# Final Drainage Report

**St. John the  
Baptist Orthodox  
Church**

**Project No. 61200**

PCD File No. PPR-22-55

MVE PROJECT 61200  
MVE DRAWING DRAIN-EX

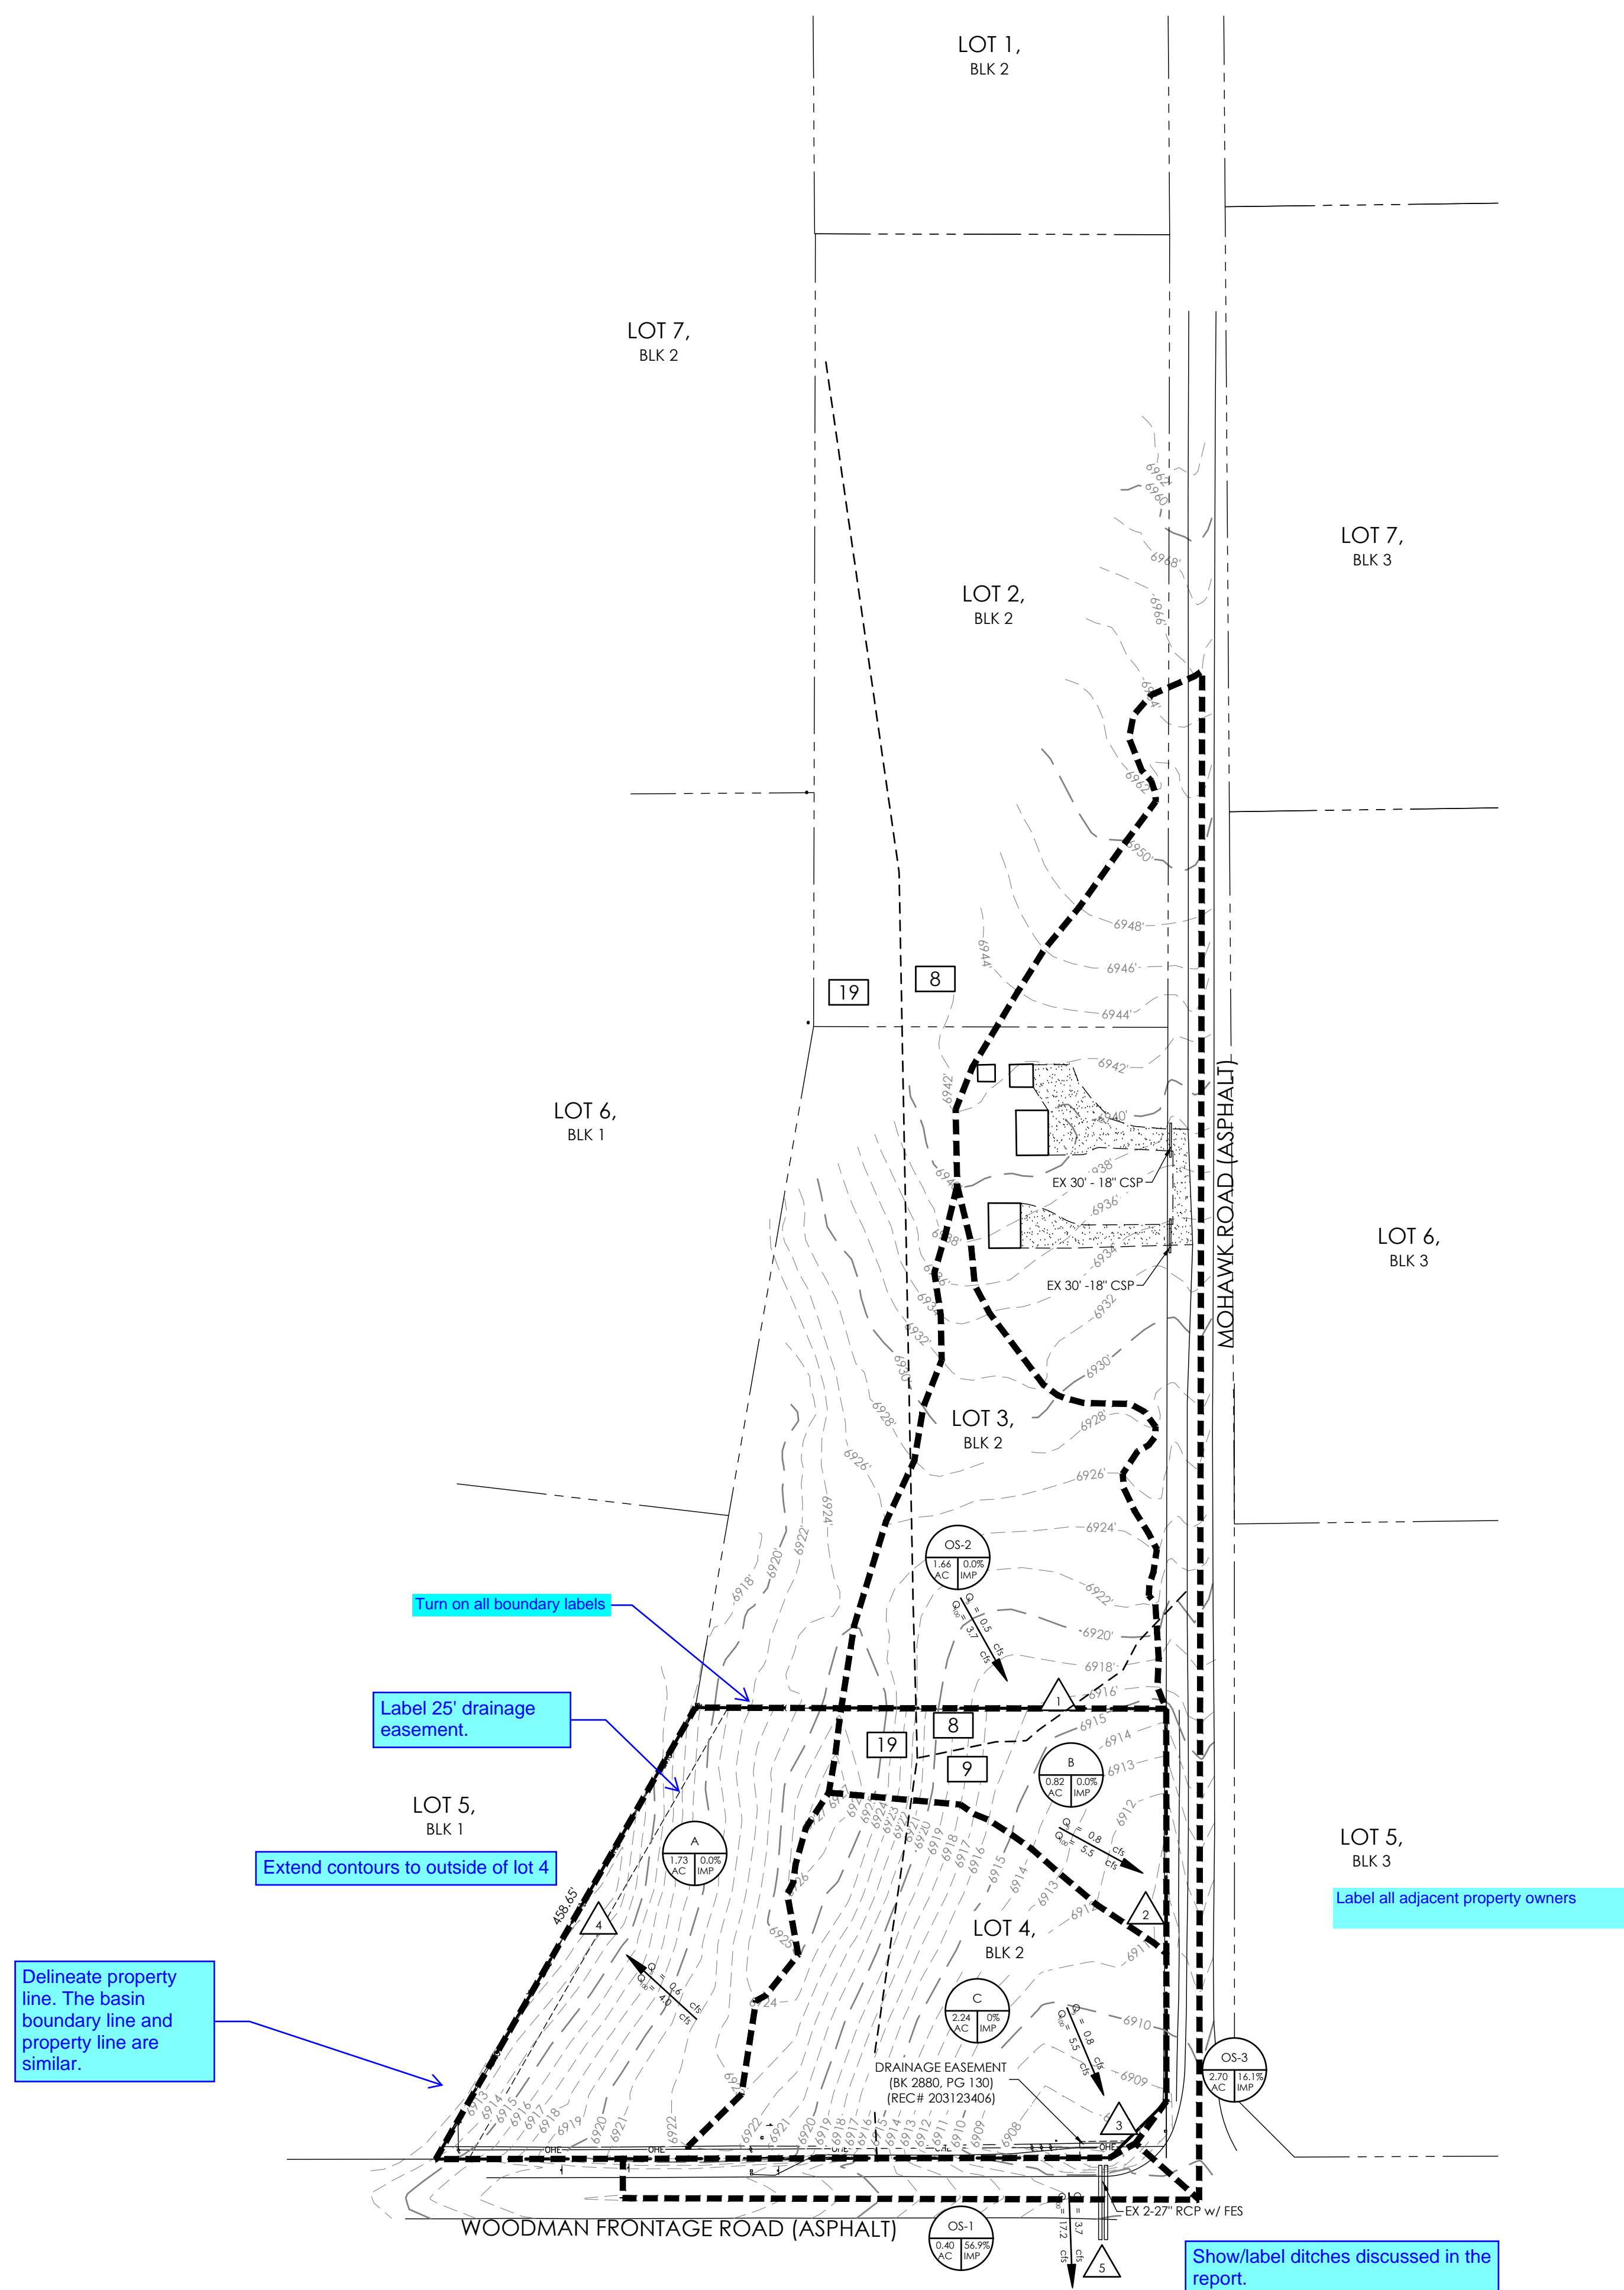
Show and label the time of concentration path

MVE PROJECT 61200  
 MVE DRAWING DRAIN-PP

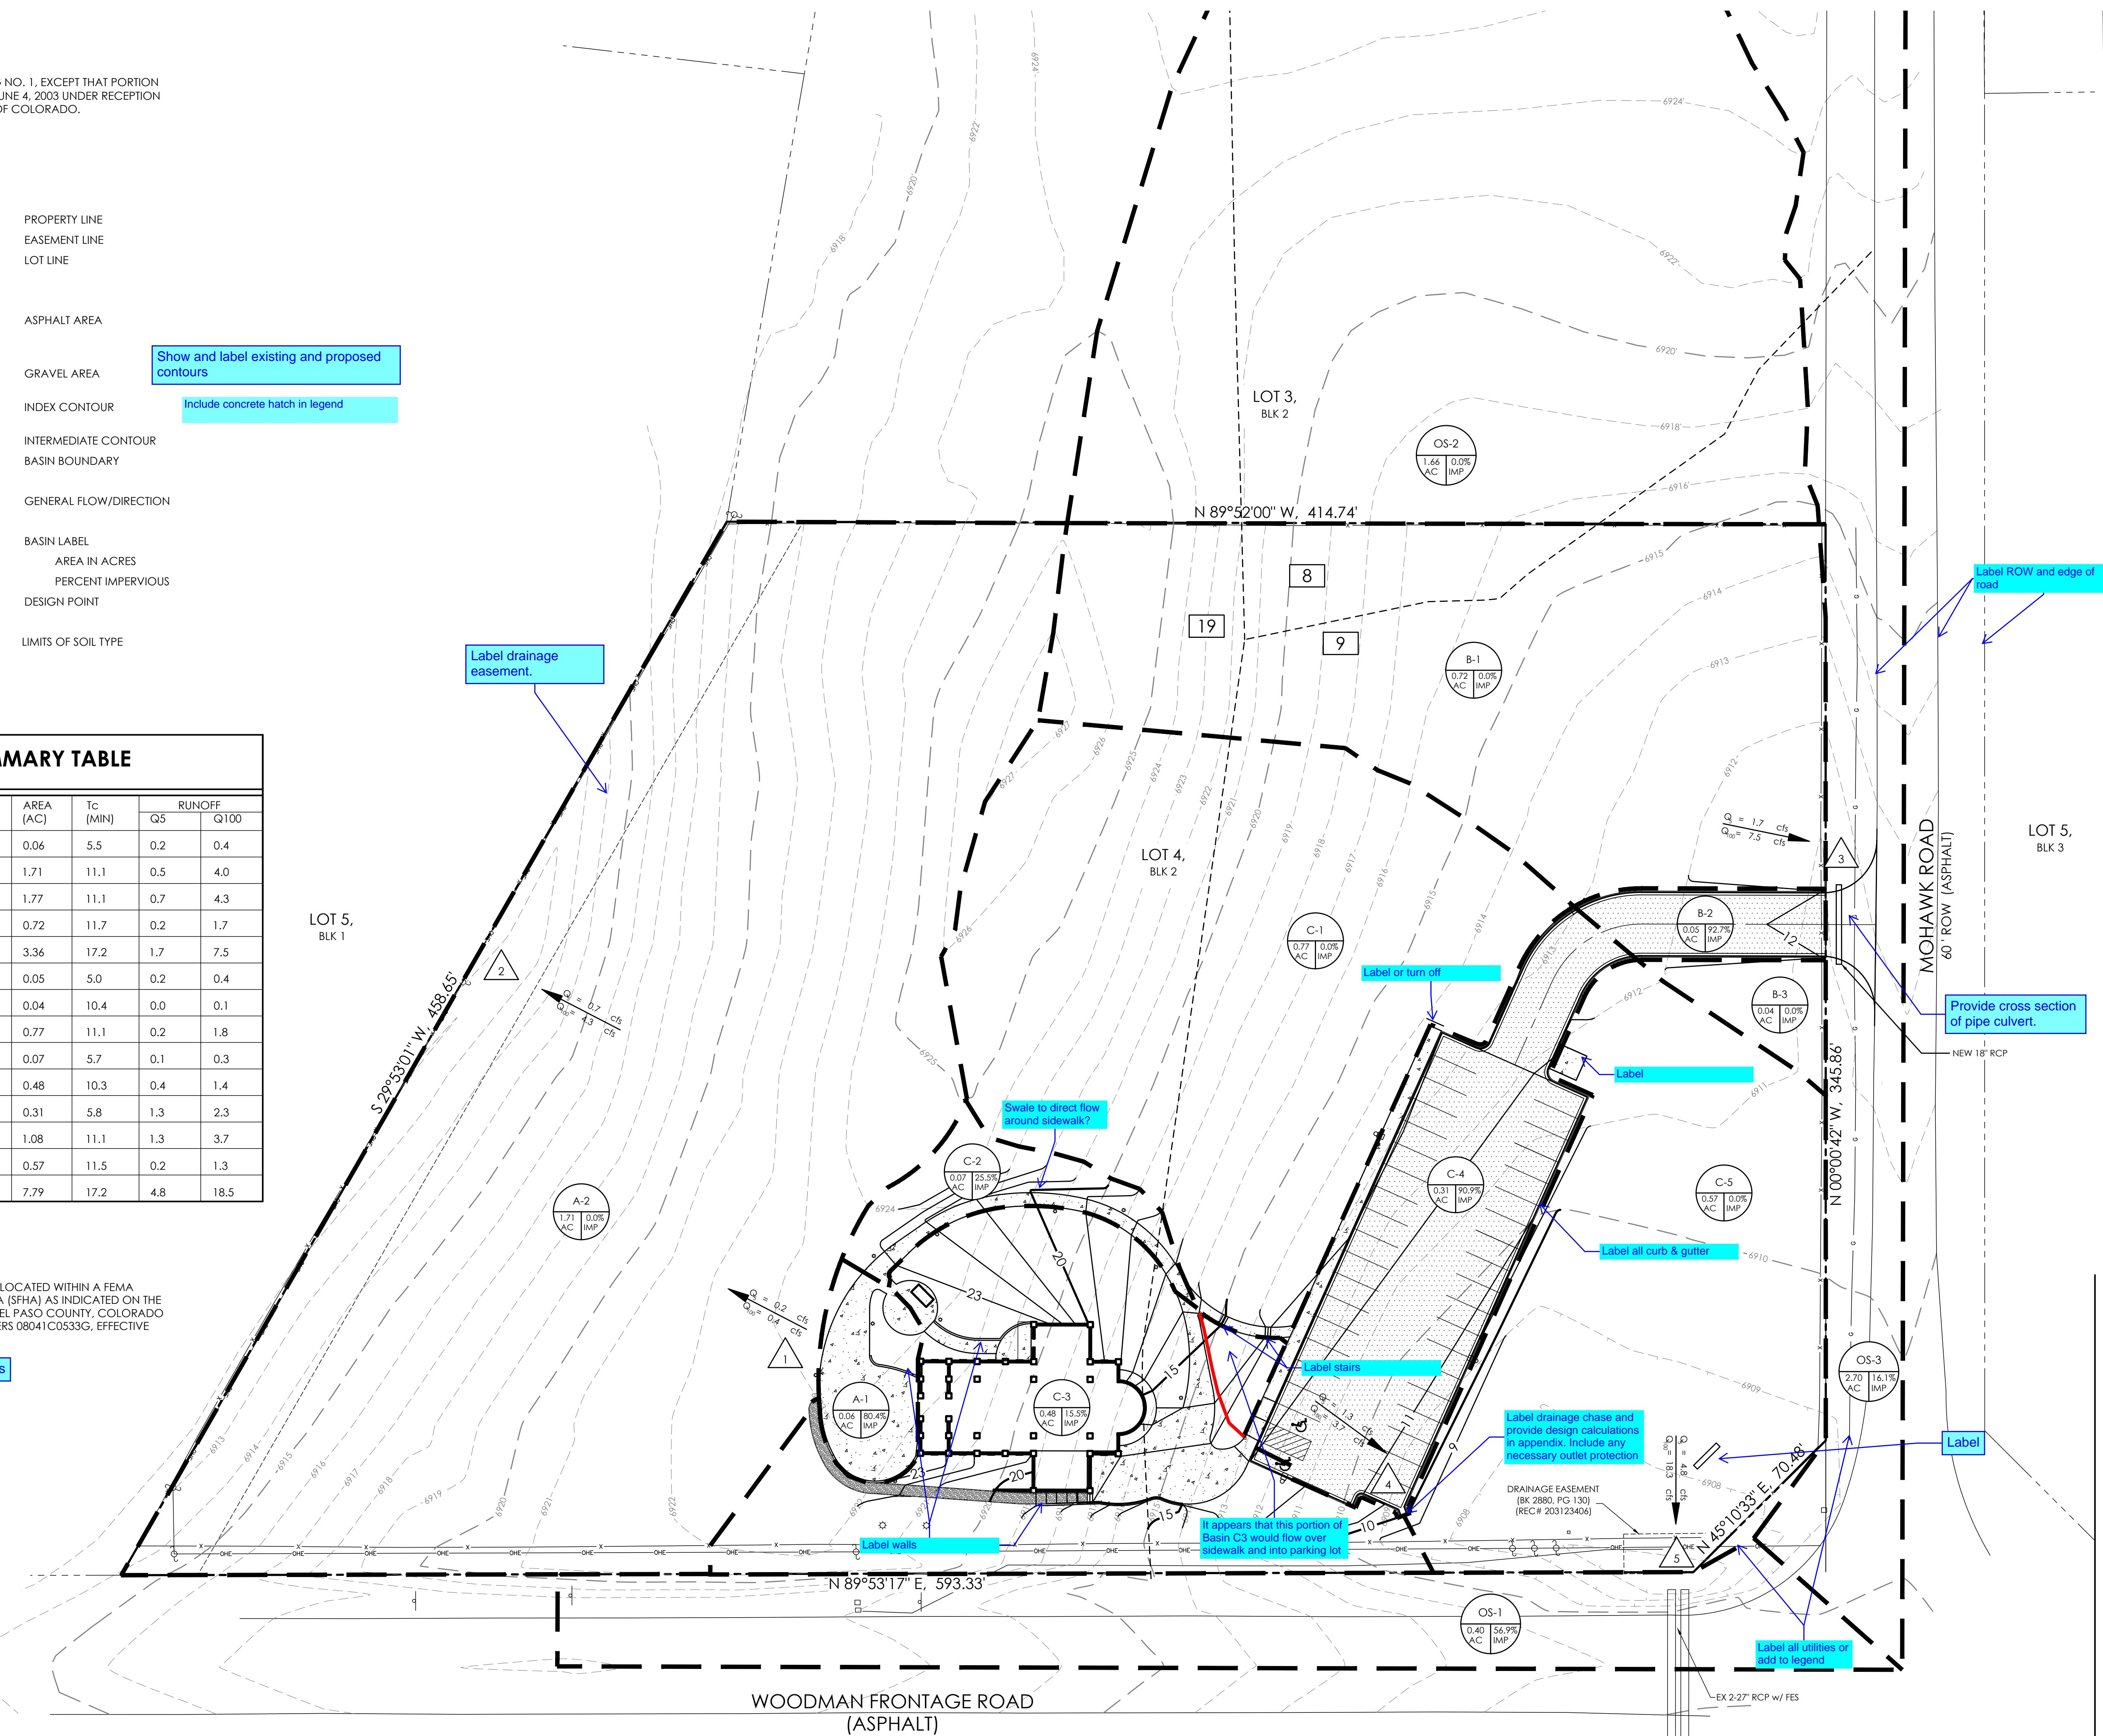
Provide a cost estimate for any proposed facilities. The drainage map shows a proposed RCP pipe.

It appears that there is a "chase or drainage" section at the SE corner of the parking lot. Please provide a calculation determining size and any outlet protection needed.

Show and label existing and proposed contours  
 Include concrete hatch in legend

Show and label time of concentration paths
